Re: GCC Energy, LLC, King II Mine

CDRMS Permit # C-1981-035

Stoner Engineering: Quarterly Inspection: Water Quality

King Coal I – Quarterly Water Quality Improvements Inspection

Pic. 3 – Inlet basin, treated water ditch at base of lower waste pile.

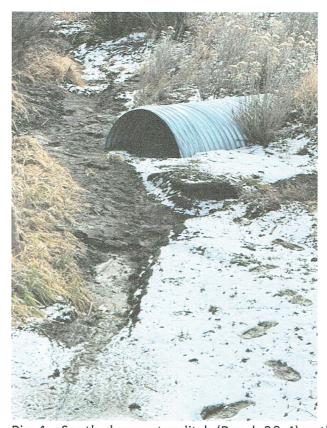
There has been some erosion of the channel for the treated water flows along the west side of the lower pile. This has also resulted in some sedimentation of the inlet basin for the culvert running under the haul road into the west detention pond (see Pic. 3). The sedimentation should be cleaned from the basin and the channel section repaired to prevent additional erosion.
